TOWN OF CORTLANDT PLANNING BOARD

**MEETING AGENDA..... PLANNING BOARD
TOWN OF CORTLANDT
6:30 TUESDAY EVENING*
FEBRUARY 3, 2026**

TO: Planning Board Members

Figure 2

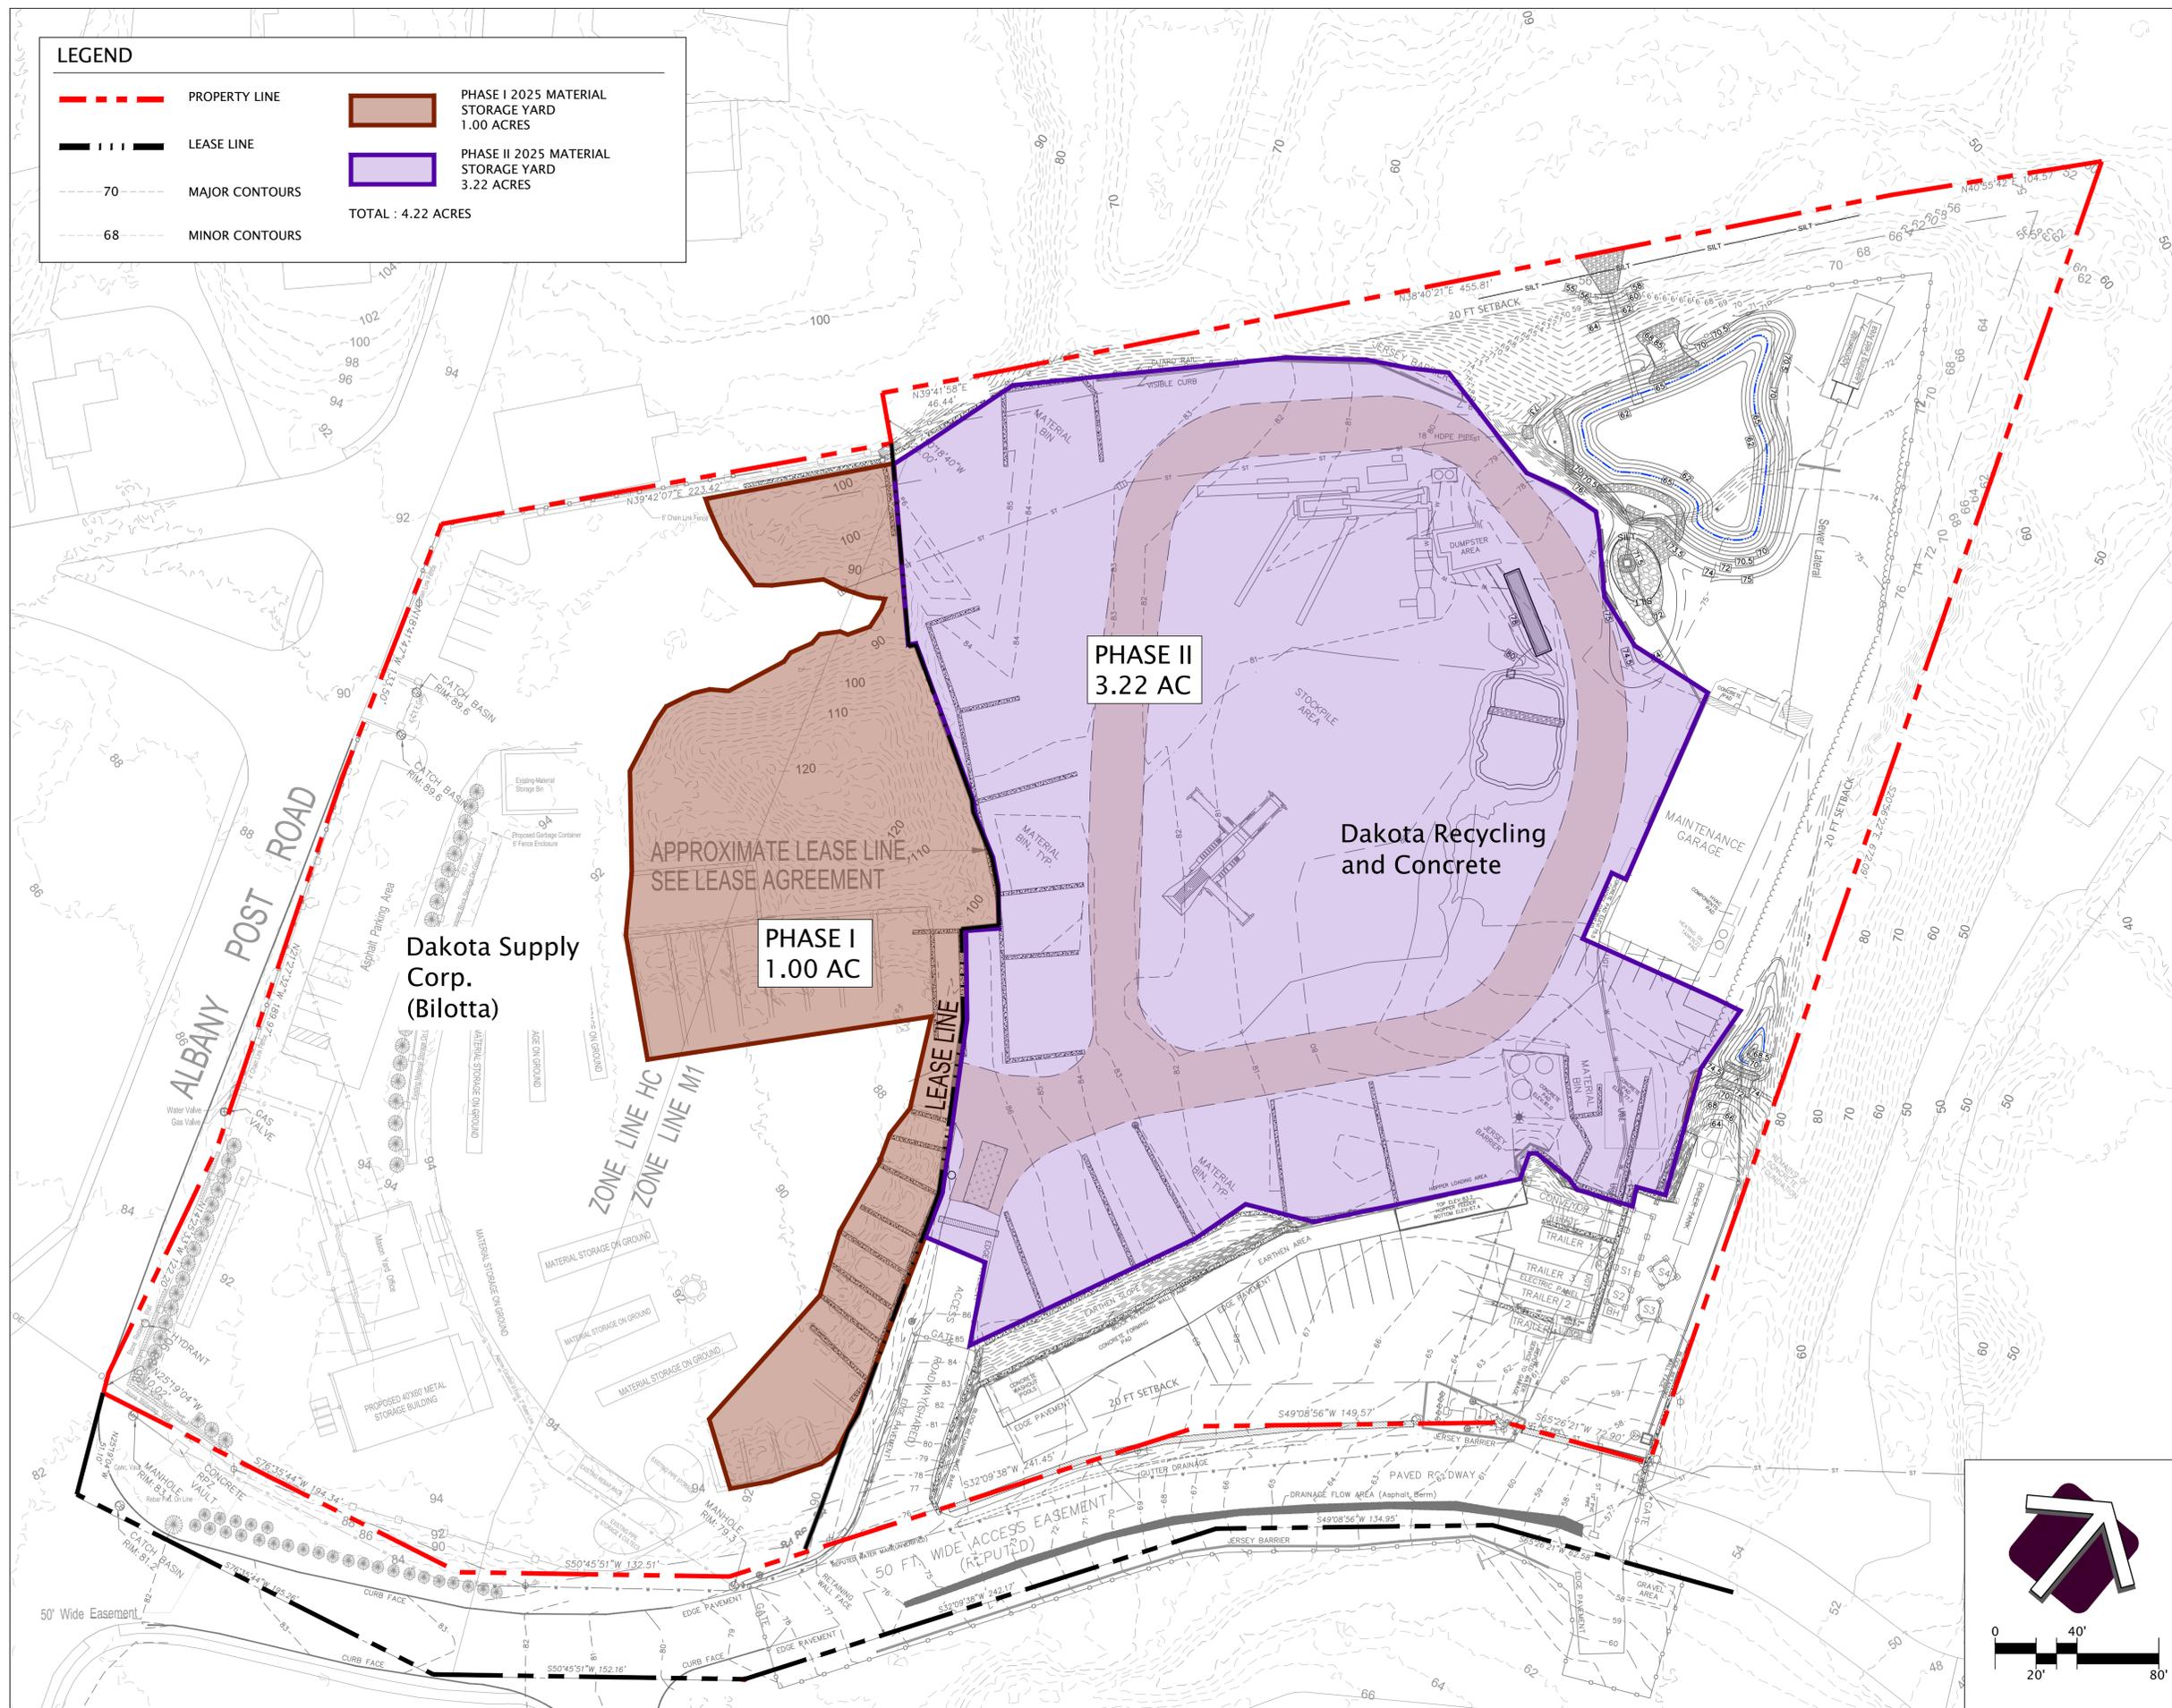
2. *The operation of the recycling facility (Dakota Recycling) expanded by 8,500 sf in the northwestern portion of the lease area, as depicted on Figure 2, where there was a former parking area, depicted on the approved site plan as part of Resolution No. 20-03 of the Planning Board of the Town of Cortlandt, New York dated June 3, 2003.*

As a comparison, the current storage yard for both recycling and concrete overall, including Phase 1 not part of this application, is 4.22 acres. See Figure 2 – 2025 Material Storage Yard.

**OVERALL SITE MAP
CLA-01**

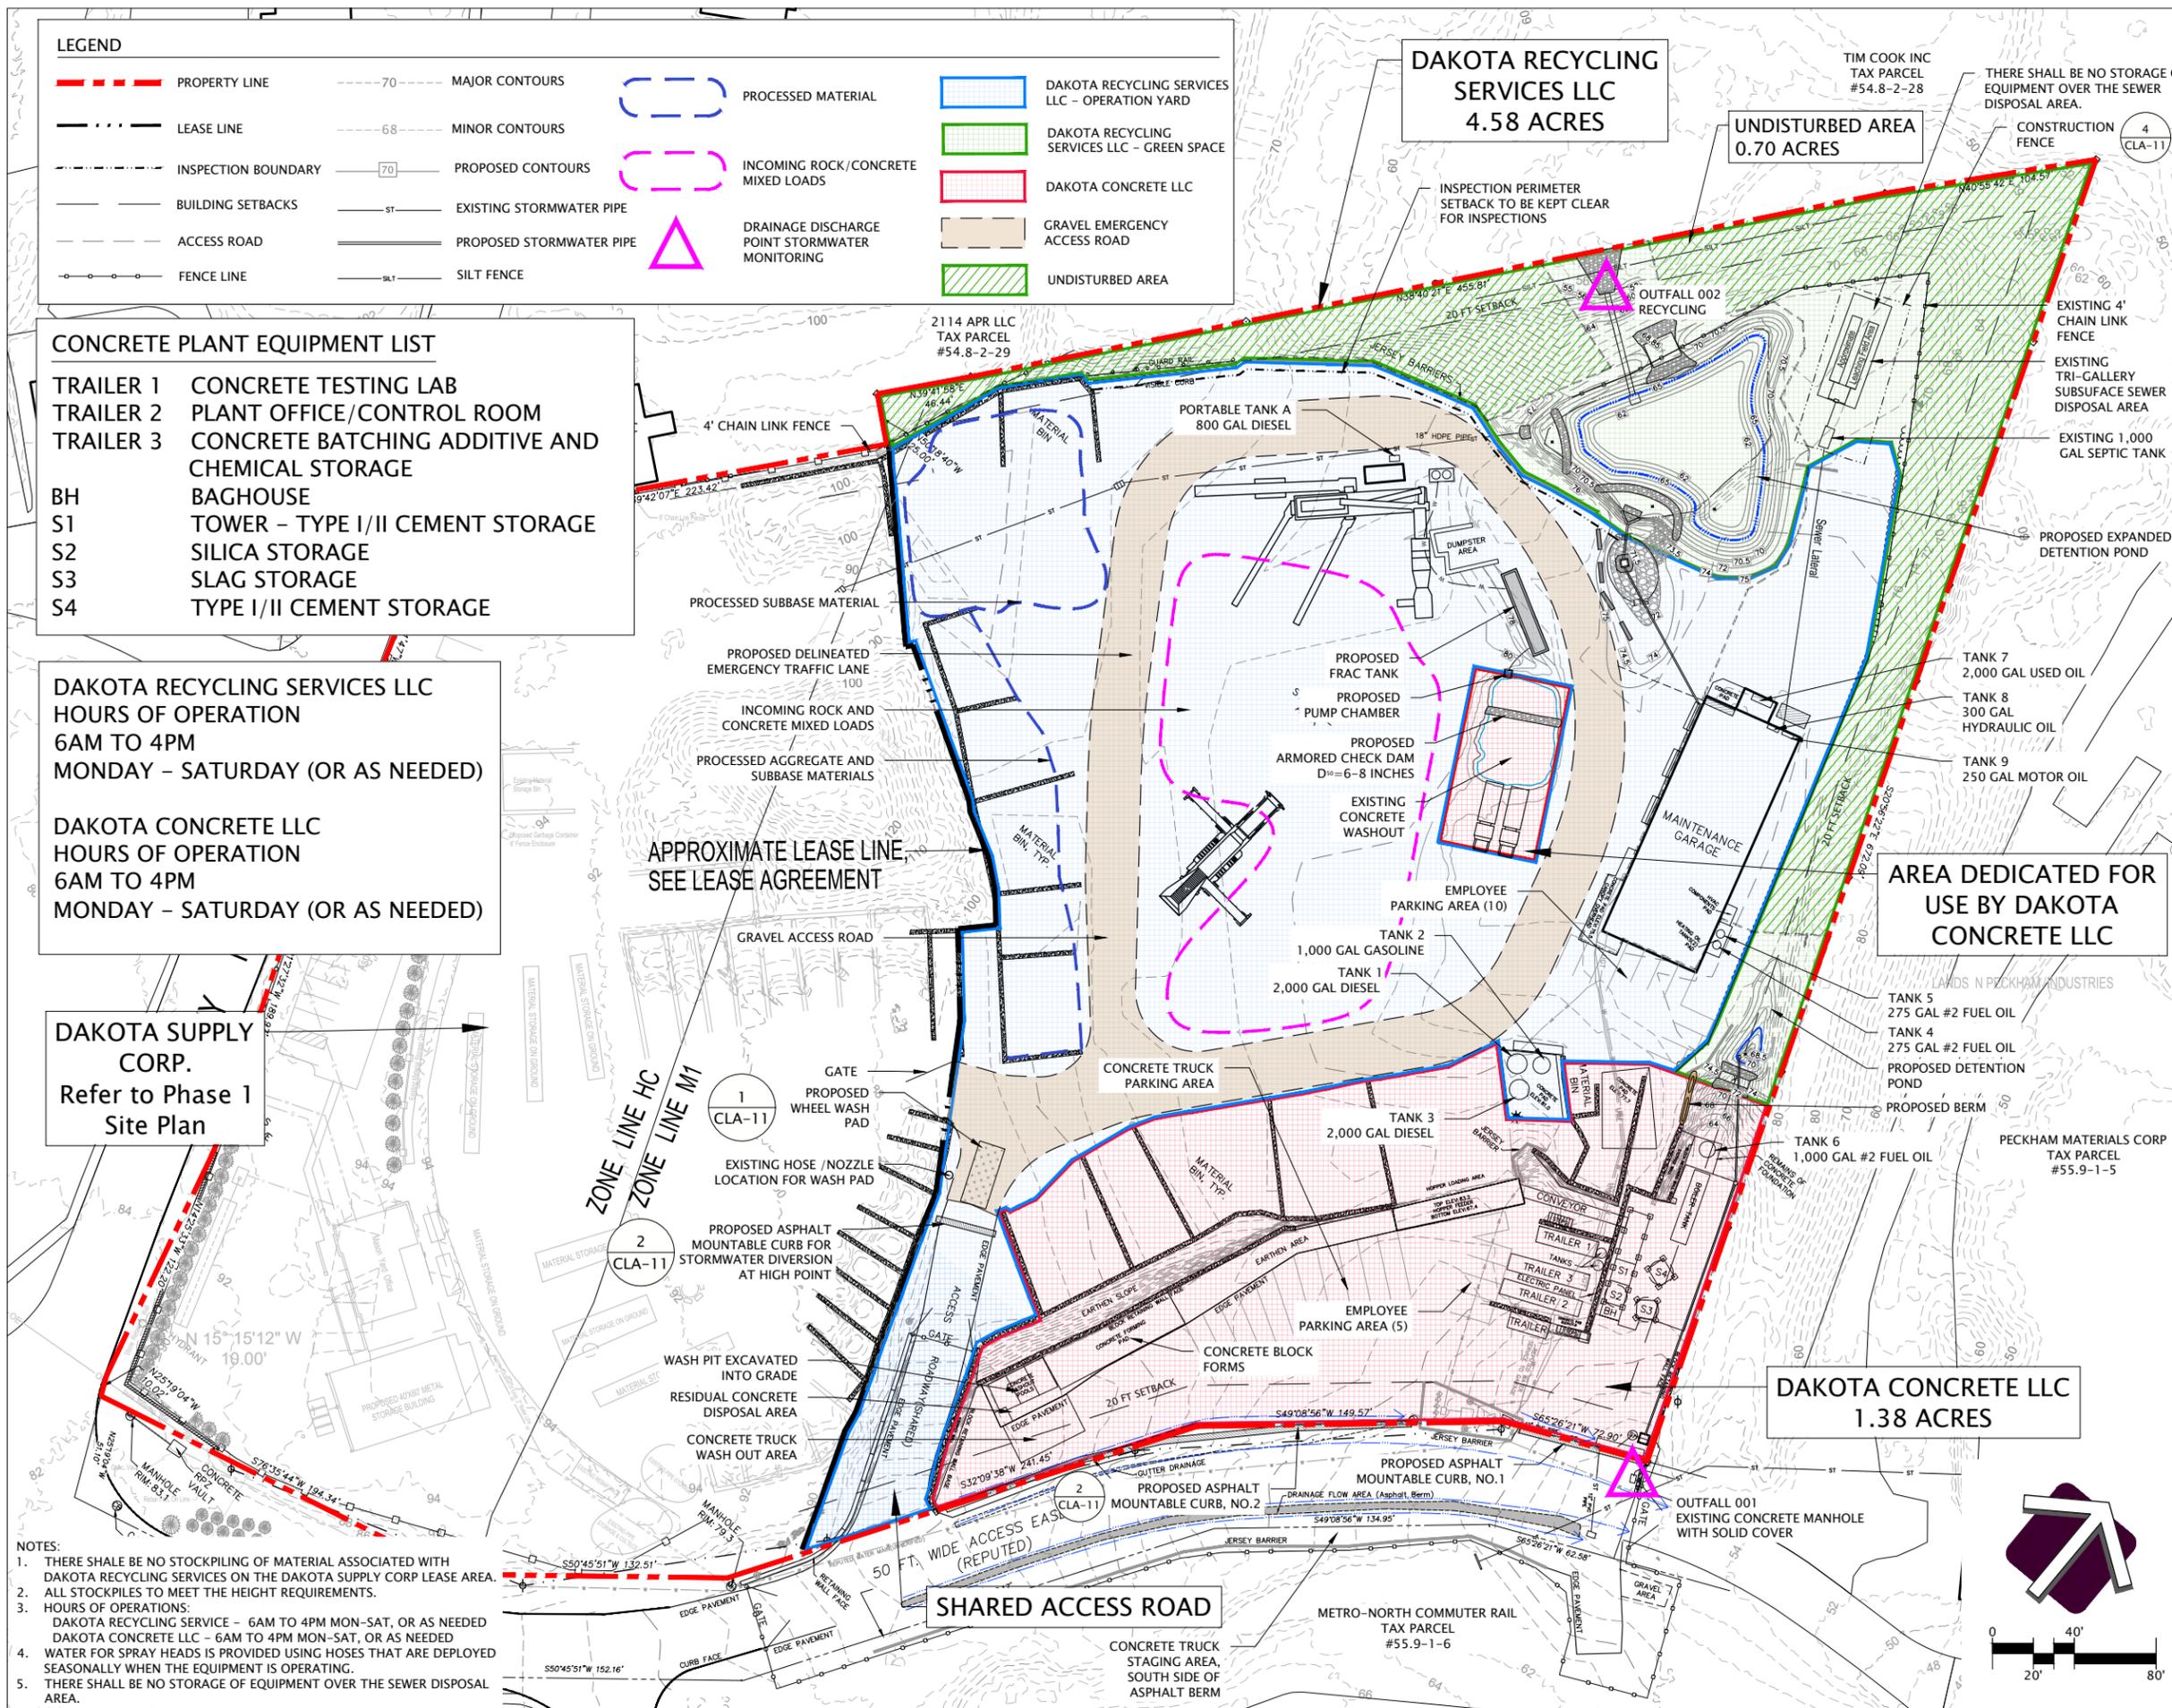
27. *CLA-04 – Clarify how water is provided for spray heads on Sandvik QE442 scalping screen, Sandvick QJ341 jaw crusher and closed-circuit plant. This should also be shown on Sheet CLA-01.*

28. *CLA-05 – Clarify how water is provided for spray heads on TS80 Stacker, 36-60 Stackers 1 and 2. This should also be shown on Sheet CLA-01.*

83. *Site Survey – The survey should be updated to match the existing condition features, utilities, and topography on the site plans shown on Sheet CLA-01-CLA-09 and STR-R2.*

Note added to drawing CLA-01.

**CONCRETE TRUCK
 WASHOUT
 LAYOUT PLAN
 CLA-08**

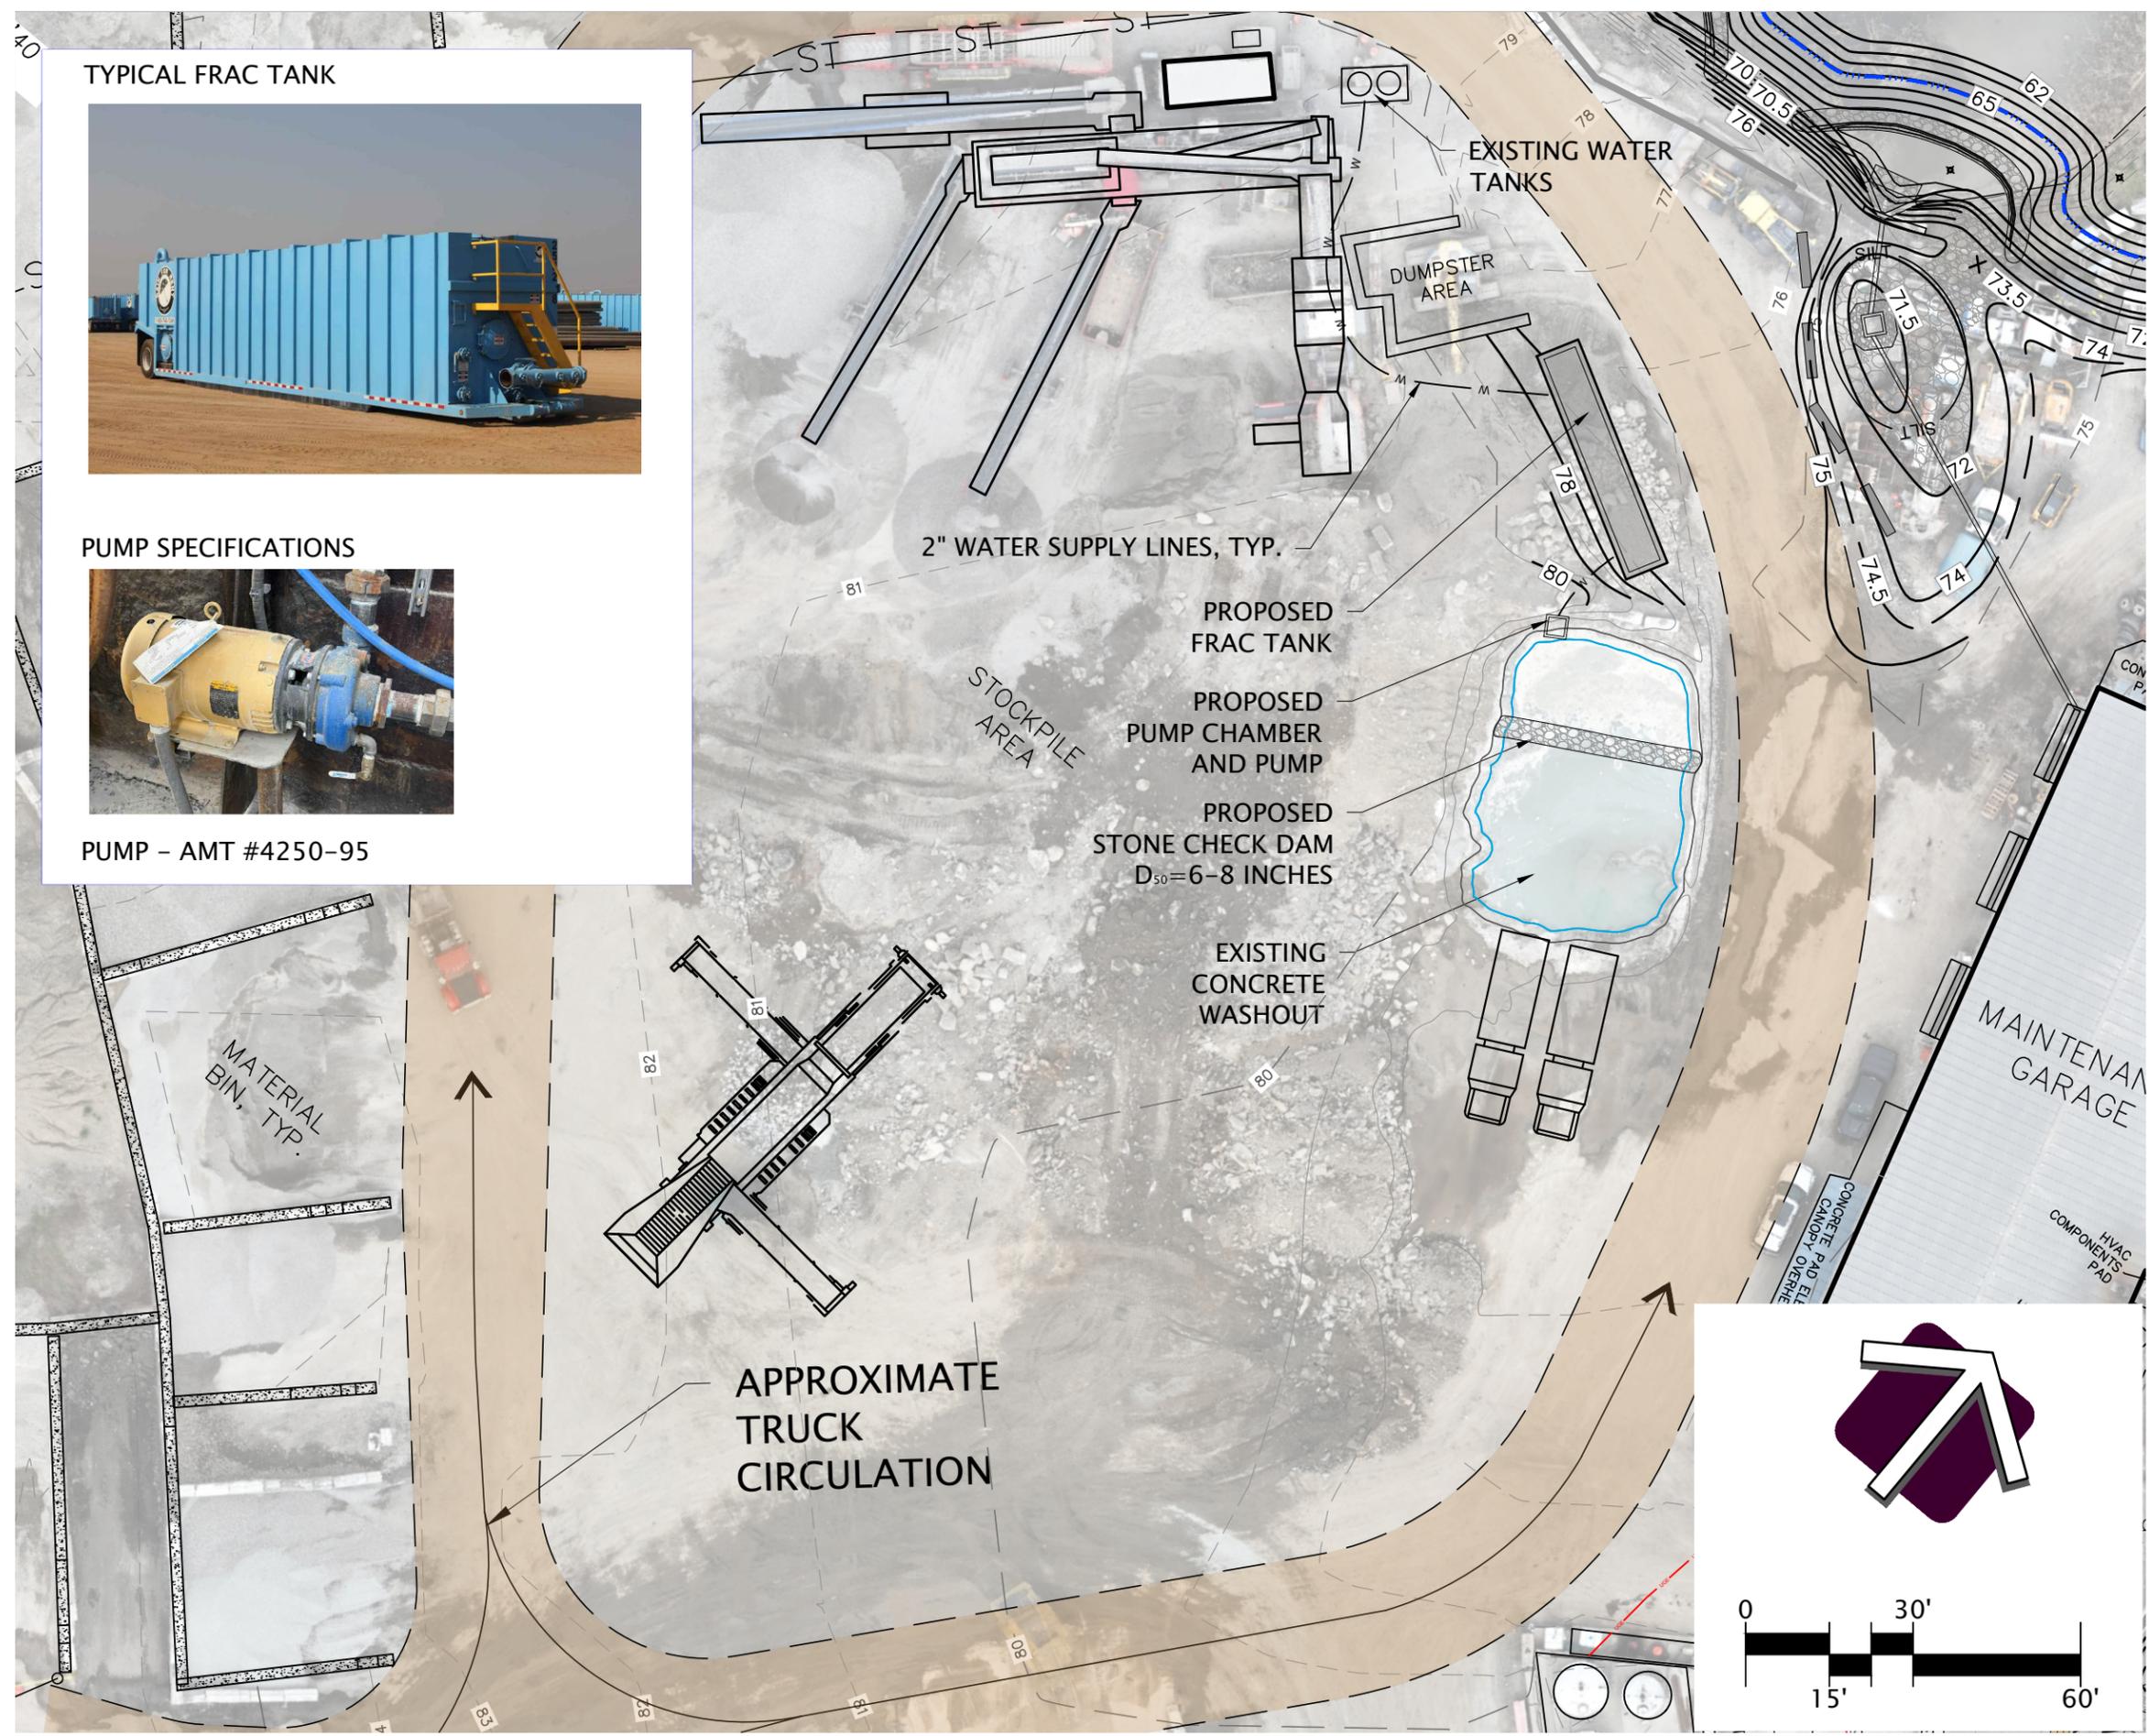
42. *CLA-09 – Depict how the new hose bib on Sheet CLA-01 is being connected to the water supply, as well as recycled wash line and pump from Sheet CLA-08.*

Pump will be located in the pump chamber. See Drawing CLA-08.
